# Lower Basin Barracks Modernization

March 24 2020  
Design Development Phase

# Agenda

**1 SECTION: PARKING LOT AT BIOSWALE**  
SCALE: 1/2" = 1'-0"

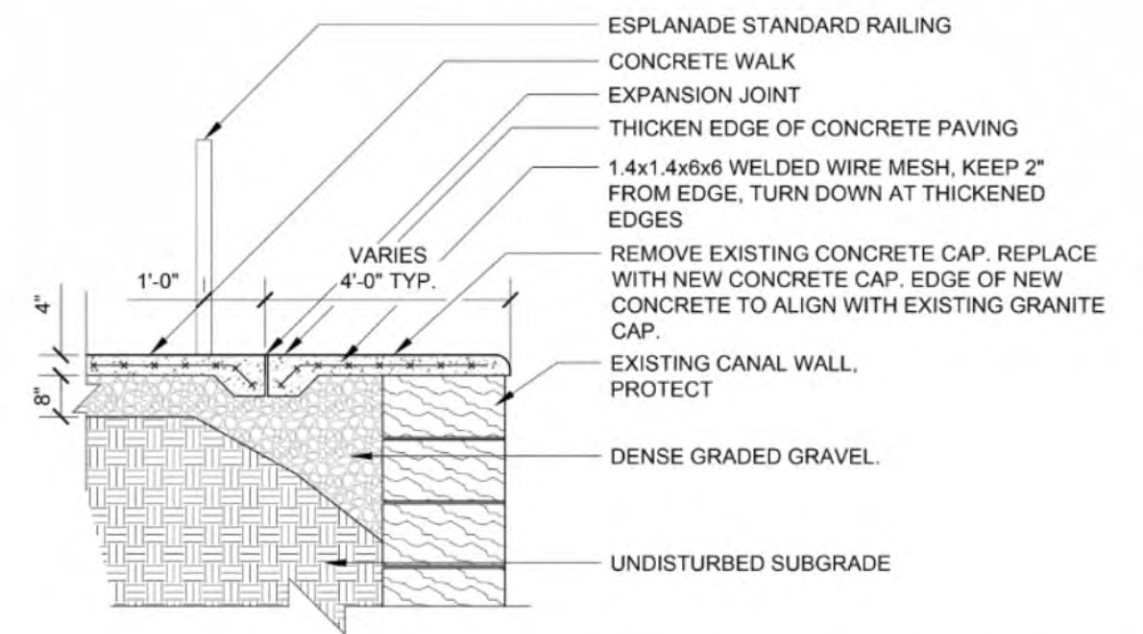
- Commissioners asked that the low, metal fence running in front of the parking lot be similar in nature, but not exactly identical, to the fence running along the river.
- Commissioners expressed concern that the bio-swale shown in the rendering would be problematic to maintain, and they asked that the parking lot be masked in another manner, perhaps with a landscape mound.
- Commissioners asked to see the final design for the gateway marker.
